Access Compliance Report

Public Rights-of-Way

(Pedestrian Signals)

Intersection ID: N/A	Main Street:	Cross Street: N/A	Location: N/A
ADA ID: 53E19587E170	Signal Type: One Push Button-Non APS	Overall Compliance: No	Severity Score: BTN 1: N/A BTN 2: N/A No BTN: N/A
Codes/Mitigation Info/Possible Solution		Field Measurements/Component Compliance

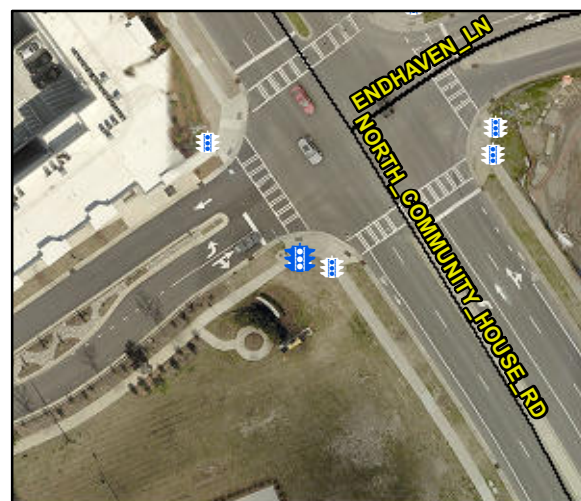
Possible Solutions: Replace Signal Push Button With APS Button on New Post. Remove & Relocate Sign.

PROW/ADA: TMUTCD 4e.08, R404.2, R404.3, R406.2
